23 December 2025

**RE: Great Wilsey Park, Haverhill - DC/25/1099/RM - Parcels A3 and A5 Reserved Matters Application**

Figure 3: Extract of original layout plots 9-12 from P22-1630\_DE\_013\_B\_01  
(red allocated parking spaces for dwellings, orange unallocated parking spaces)

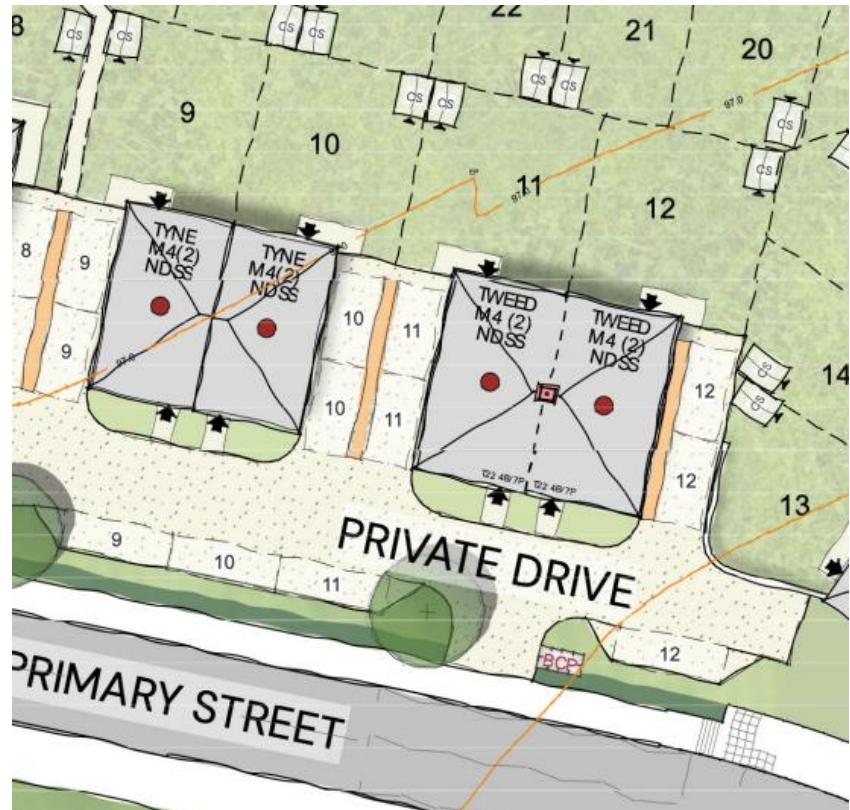
#### HTC Comment 2 - Parking Arrangements for properties 9-12

Councillors have raised concerns over the triple parking arrangements for properties 9-12. A screenshot of this location has been included below (the full plans can be viewed once submitted back to the LPA in early January 2026 as part of an amended application pack).

Figure 4: Amended parking arrangements for plots 9-12 omitting the triple parking

The Tyne and Tweed house types are 4-bedroom properties with a minimum parking requirement of 3 spaces per dwelling (Suffolk Guidance for Parking 2023).

Redrow's design team has revisited this area to seek to address your comments and have amended the parking layout to omit the triple parking associated with these plots. This has been achieved by relocating the third parking space to the front of the dwelling. The parking spaces located within the private drive are now screened from the primary street by a hedgerow which extends its full length. This also screens the Bin Collection Point to the south of plot 12's third parking space, improving the street scene along the primary street.
